## **MAGNOLIA SPRINGS SUBDIVISION,**

### **PHASE I**

APPLICATION NUMBER 22 DATE November 15, 2007  
APPLICANT Magnolia Springs Subdivision, Phase One  
REQUEST Subdivision

DETAIL SITE PLAN

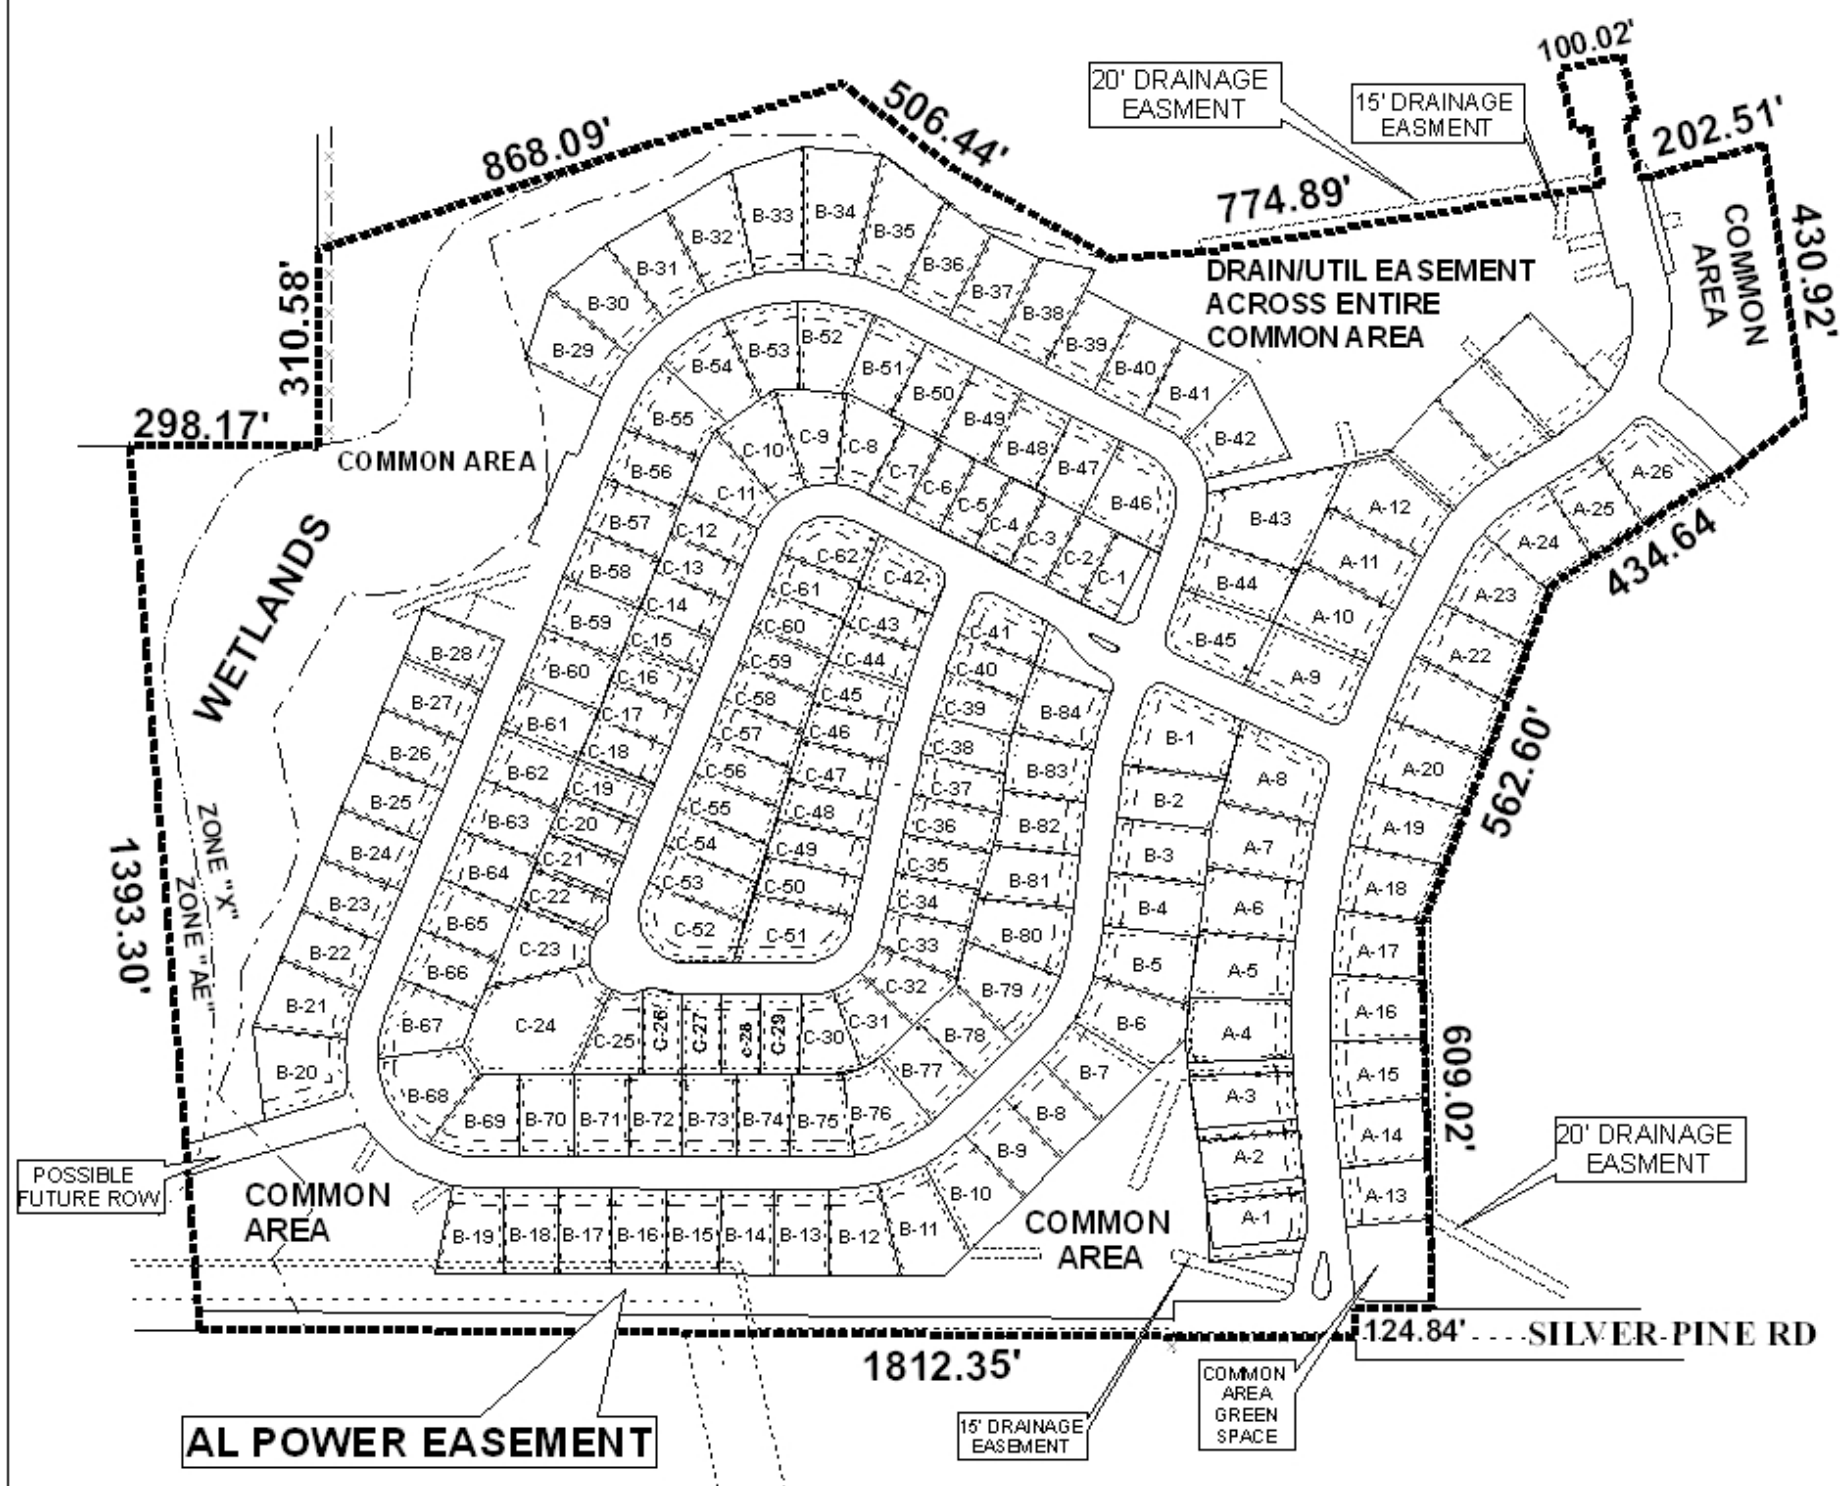
The new roads for the site are to be dedicated and constructed to meet County Engineering Standards. Additionally, since Lots A-8, A-9, A-26, B-1, B-20, B-45, B-46, C-41, C-42, C-51, C-52 and C-62 are corner lots, a note should be placed on the Final Plat stating that these are limited to one curb-cut each with the size, design and located to be determined by County Engineering.

The areas of open space are labeled as common area, as are areas of wetlands, islands or medians in the roadway, areas containing lakes and other amenities, as well as detention areas. All areas not designated as lots should be labeled as common areas, and a note should be required on the final plat, if approved, stating that maintenance of all common areas is the responsibility of the property owners (association).

While the site is in the County, the applicant's engineer will be required to certify that the stormwater detention, drainage facilities, and release rate comply with the City of Mobile stormwater and flood control ordinances, prior to the signing and recording of the final plat, if approved. The plat should also be revised to depict lot sizes to be illustrated in square feet either through labeling or the provision of a table on the Final Plat.

2. the placement of a note on the Final Plat stating that A-8, A-9, A-26, B-1, B-20, B-45, B-46, C-41, C-42, C-51, C-52 and C-62 are corner lots, are limited to one curb cut, with the size, design and location to be determined by County Engineering;

6. all areas not designated as lots should be labeled as common areas (including wetlands and detention areas), and a note placed on the final plat stating that maintenance of all common areas is the responsibility of the property owners (association);

9. Depiction of the 25-foot minimum building setback line on all lots and common areas, on the final plat;
10. Placement of a note on the final plat stating that the maintenance of all common areas shall the responsibility of the property owners;

12. labeling of all lots with size in square feet, or placement of a table on the plat containing the lot size information.
